1997 - 1998 Corvette: Service Bulletin: Discoloration or Staining of Plenum (Cowl) Air Inlet Screen

Source: Chevrolet Dealer Technical Service Bulletin

Number: 83-15-11

Models: 1997-1998 Chevrolet Corvette

Figure 1

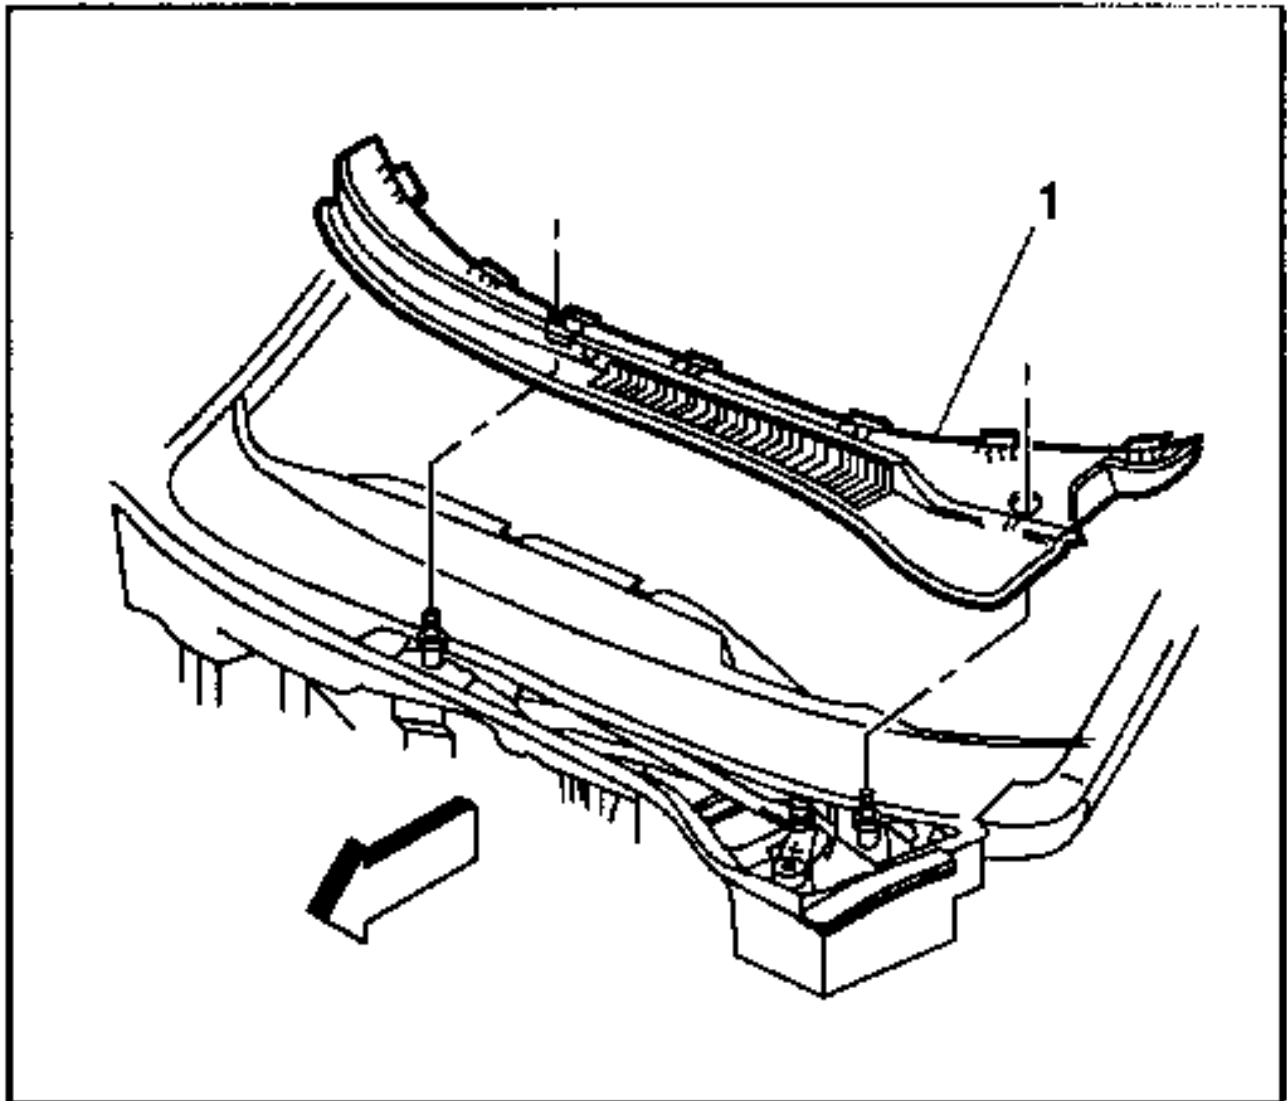
Condition: SOME CUSTOMERS MAY COMMENT THAT THERE ARE WHITISH SPOTS OR STAINS ON THE PLENUM AIR INLET SCREEN AT THE BASE OF THE WINDSHIELD. THESE SPOTS OR STAINS ARE USUALLY FOUND IN THE AREAS AROUND AND BELOW THE WINDSHIELD WIPER ARMS AND BLADES.

THIS CONDITION MAY BE CAUSED BY A CHEMICAL RESIDUE USED IN THE MANUFACTURING PROCESS OF THE WINDSHIELD WIPER WASHER NOZZLES. RESIDUE IS WASHED OUT FROM INSIDE THE NOZZLES DURING THE FIRST FEW USAGES OF THE WINDSHIELD WIPER WASHERS.

INSTALL NEW AIR INLET SCREEN (P/N 10418245), USING THE PROCEDURES IN THE APPROPRIATE SERVICE MANUAL
